V2500 Propulsion System — Nacelle

SERVICE BULLETIN

Subject: Transmittal of Revision 2 to Service Bulletin Number V2500-NAC-71-0168

NACELLE — POWER PLANT — OUTER BREATHER MAST, LOWER FAN COWL
DOOR — REPLACEMENT OF

OUTER BREATHER MAST ASSEMBLY REMOVAL/INSTALLATION
FIGURE 1

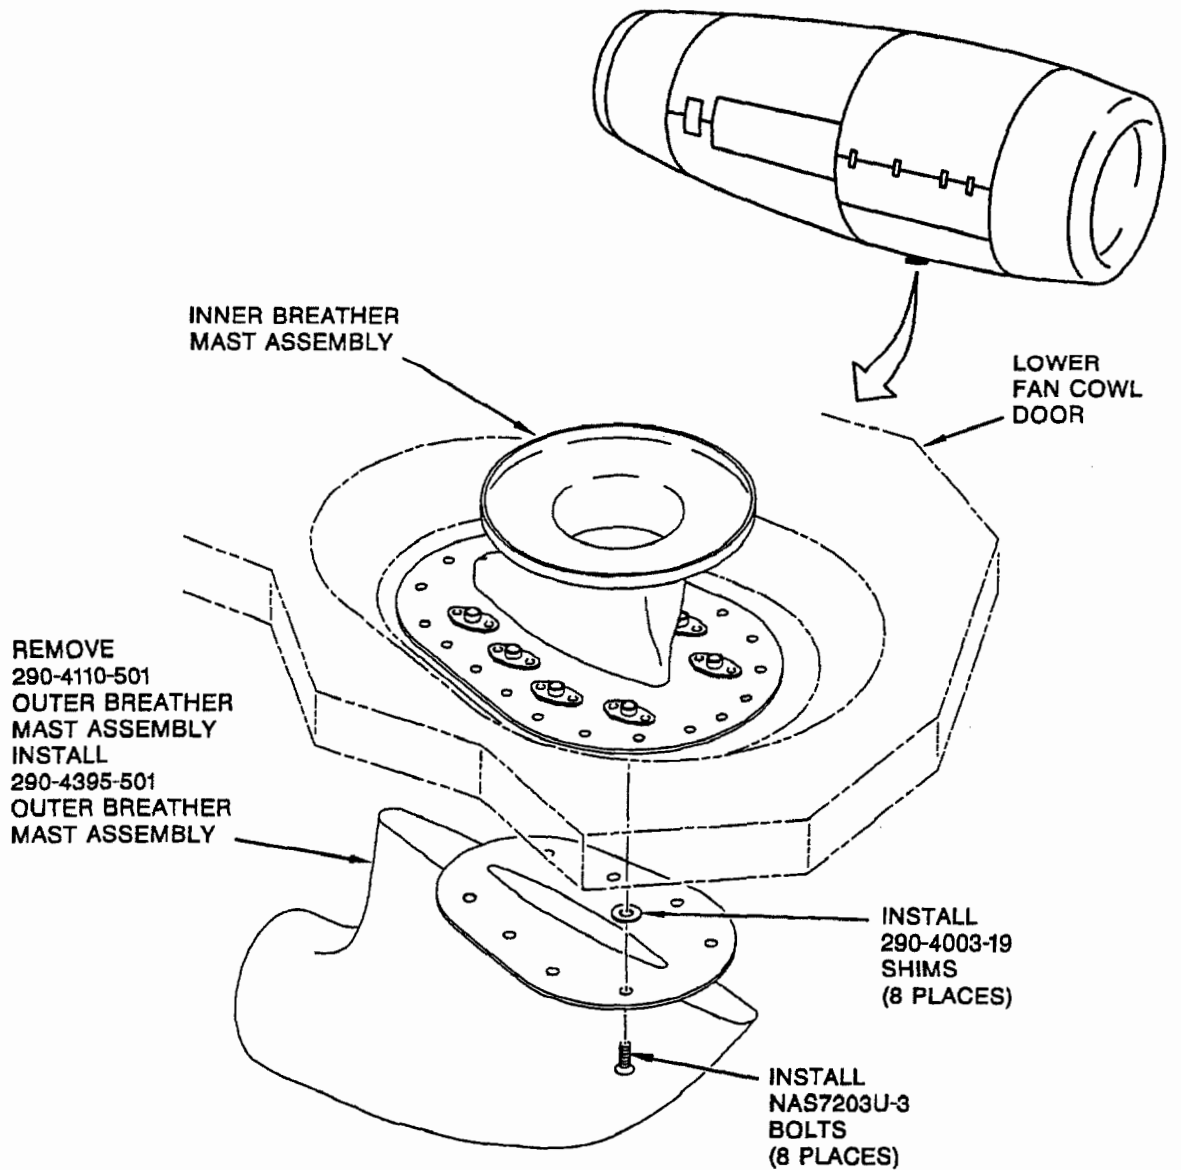
(1) Remove eight NAS7203U3 bolts, eight 290-4003-19 shims, and 290-4110-501 outer mast assembly from left lower fan cowl door. Refer to Figure 1. Keep bolts. Discard outer mast assembly and shims.

(4) Put 290-4395-501 outer mast assembly and eight replacement 290-4003-19 shims on lower fan cowl door. Install and hand-tighten eight NAS7203U3 bolts. Refer to Figure 1.

AERODYNAMIC GAP REQUIREMENTS
FIGURE 2

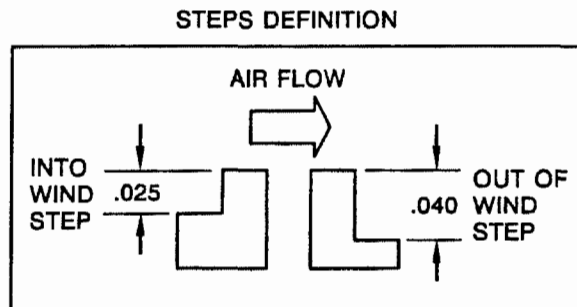
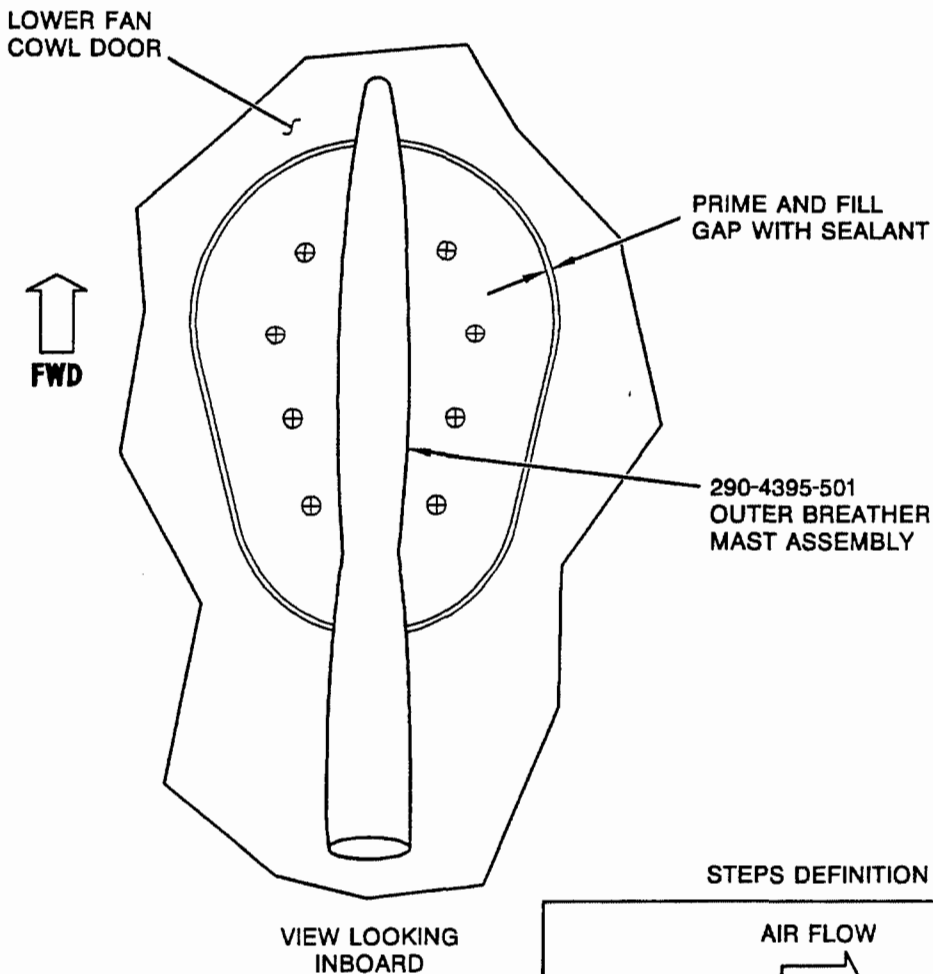
- (5) Measure step between outer mast assembly base plate and fan cowl door outer surface. Steps should be no more than 0.025 inch (0,635 mm) into wind, 0.040 inch (1,016 mm) out of wind, and 0.040 inch (1,016 mm) streamwise. Refer to Figure 2.
- (6) Remove eight NAS7203U3 bolts, outer mast assembly, and eight laminated shims. If necessary, peel excess thicknesses from eight 290-4003-19 laminated shims to get proper aerodynamic step requirements from paragraph 2.B.(5).
